Project	IEEE 802.16 Broadband Wireless Access Working Group < http://ieee802.org/16 >	
Title	Changes in P802.16-REVd/D2-2003 for Bulk ACK/NACK Feedbacks	
Date Submitted	2003-12-29	
Source(s)	Kunmin Yeo, Chulsik Yoon and Byung-Han Ryu ETRI 161 Kajong Dong, Yuseong Gu, Daejon, Korea.	Voice: +82-42-860-5438 Fax: +82-42-860-6732 mailto: kunmin@etri.re.kr
Re:	IEEE 802.16d	
Abstract	This document contains suggestions on the changes in IEEE P802.16-REVd/D2-2003 that would help transmitting bulk type of ACK/NACK feedbacks for the groups of blocks.	
Purpose	The document is submitted for review by 802.16 Working Group members	
Notice	This document has been prepared to assist IEEE 802.16. It is offered as a basis for discussion and is not binding on the contributing individual(s) or organization(s). The material in this document is subject to change in form and content after further study. The contributor(s) reserve(s) the right to add, amend or withdraw material contained herein.

Changes in P802.16-REVd/D2-2003 for Bulk ACK/NACK Feedbacks

C802.16d-03/89

Replace Figure 34—ARQ transmit block states

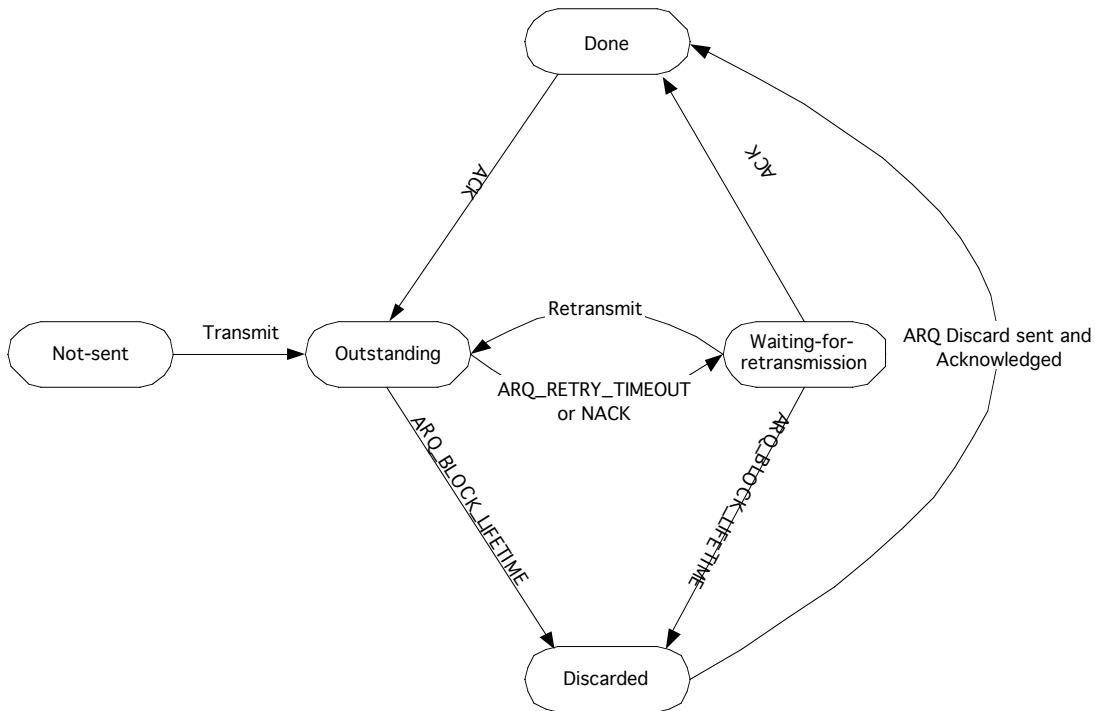
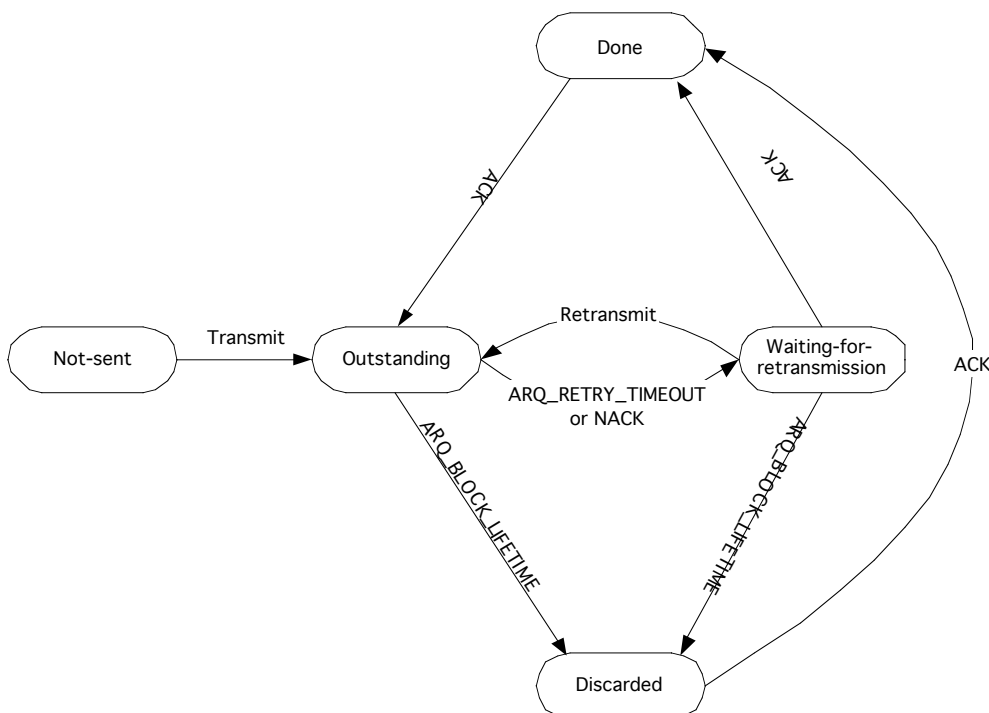
Additionally, we also propose some changes in the ARQ transmit block states (Figure 34) and the ARQ block reception (Figure 37) to give more completeness to IEEE P802.16-REVd/D2-2003 Document.

In the event of “Discarded” state, the sender usually transmits a Discard message; the only way to acknowledge the message is through the ARQ feedback message; before sending the Discard message a number of corresponding blocks can be acknowledged. Hence, whether the Discard message has been sent or not, the corresponding blocks should go to the “Done” state immediately after reception of ACK.

to

Replace Figure 37—ARQ block reception

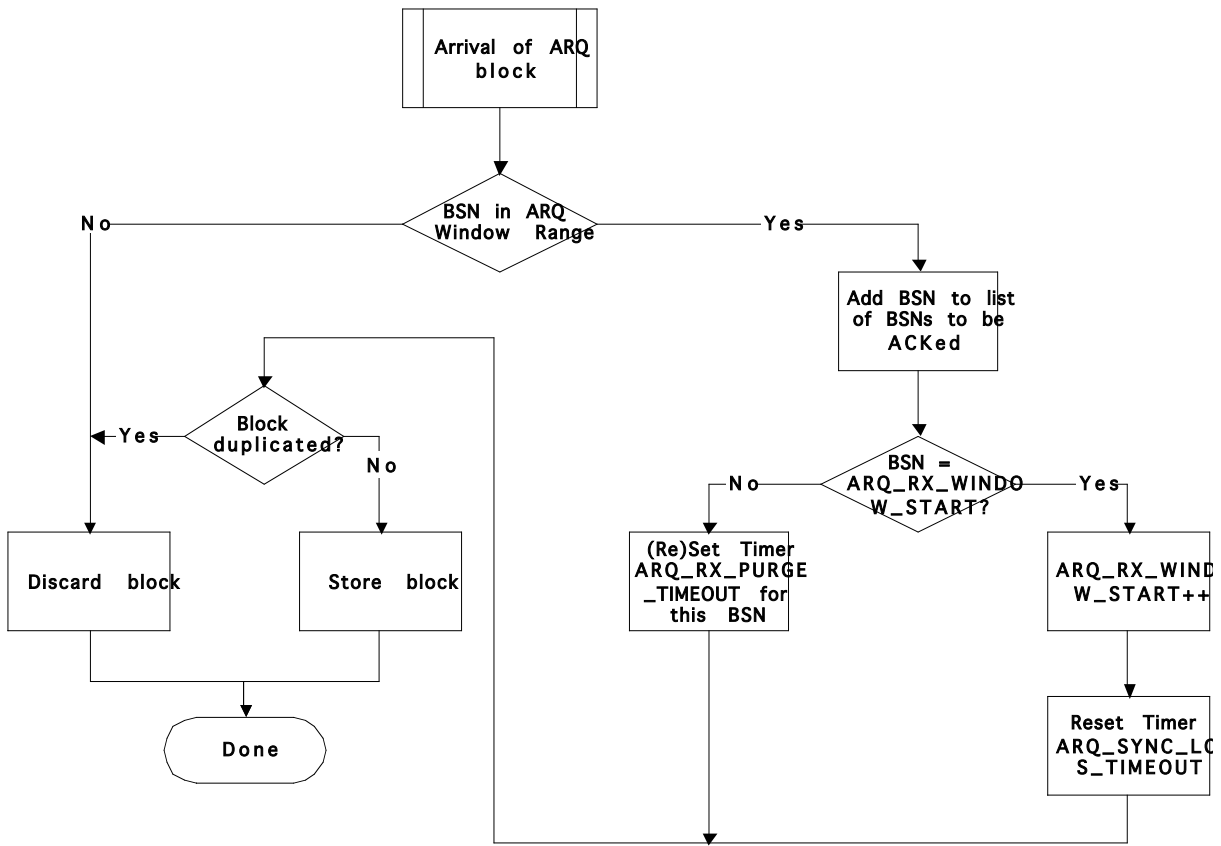
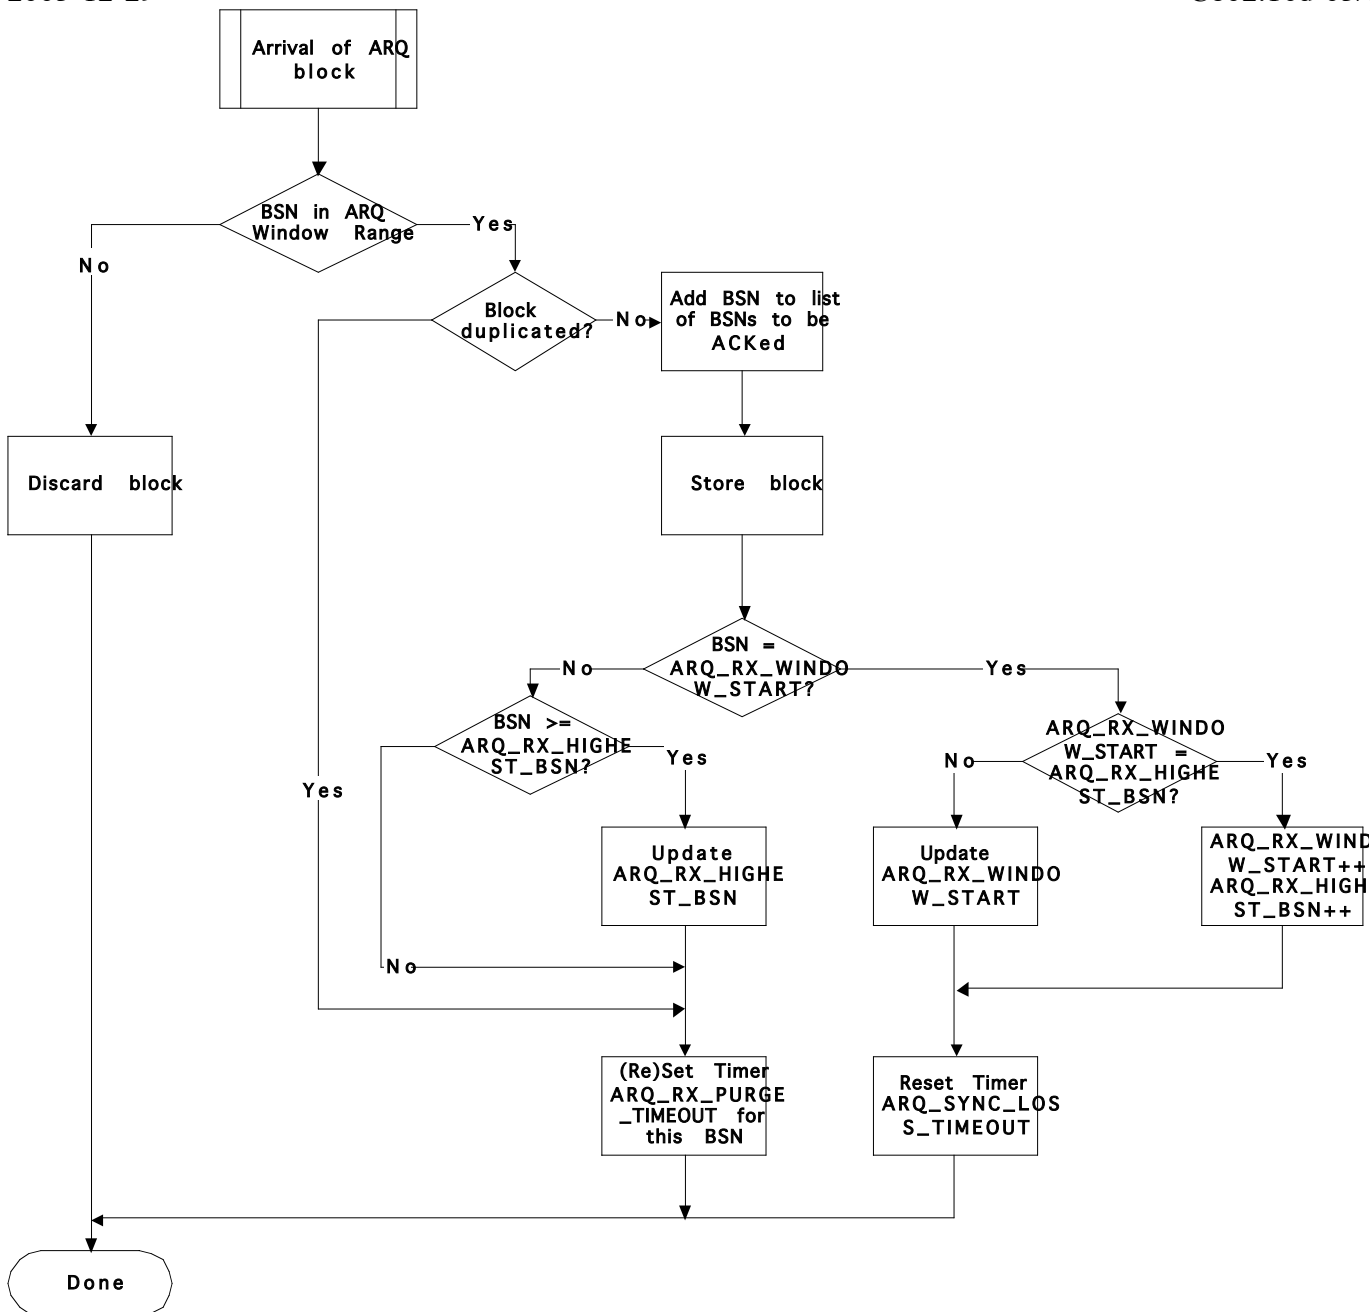
There are some problems in this reception machine with respect to updating the *ARQ_RX_WINDOW_START* and the *ARQ_RX_HIGHEST_BSN*. There are no flows in the following cases:

- Reception of $BSN \geq ARQ_RX_HIGHEST_BSN$
- Reception of $BSN = ARQ_RX_WINDOW_START = ARQ_RX_HIGHEST_BSN$
- Reception of BSN which updates *ARQ_RX_WINDOW_START* with amount of $\Delta (> 1)$

Our proposal provides the steps for these events including an enhanced procedure at the event of “Block duplicated”.

to
